South Harbor Rebuild Request for Proposals ADDENDUM # 7

Addendum #7 The estimated exclusion zones and the number of Marine Mammal Observers that will be required

Cordova Harbor Rebuild Project Level B By Sound Unit Monitoring and Shutdown Zones— South Harbor <u>City_of_Cordova</u>

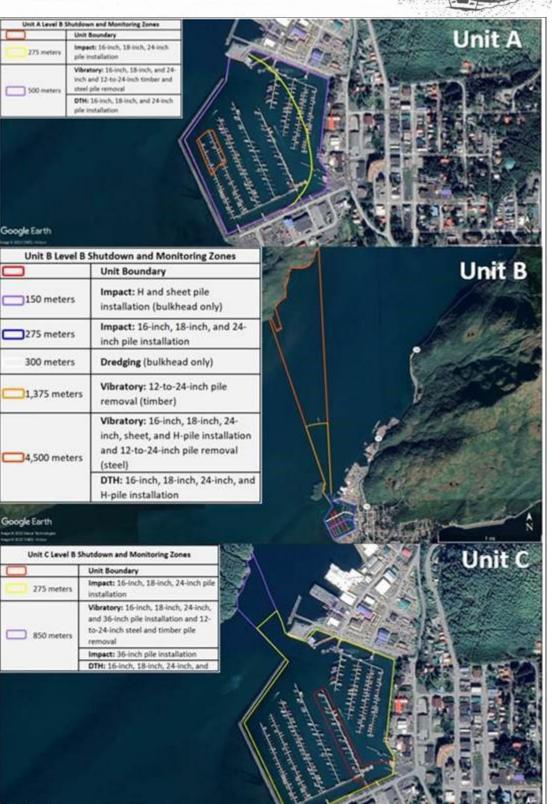
1. Question: Can you please tell us what to assume for the exclusion zones and the number of Marine Mammal Observers that will be required?

Response: We expect that the maximum number of observers will be 3. See the table below for exclusions.

Below is a table of distances for the South Harbor work. Note that the sound transmission would be blocked by landforms, as shown in the figure below. Note that the project will be requesting Level B and Level A take of common marine mammals in the harbor (sea otters, void injury. seals, sea lions). There will be a minimal shutdown for marine mammals within

the harbor to avoid injury.
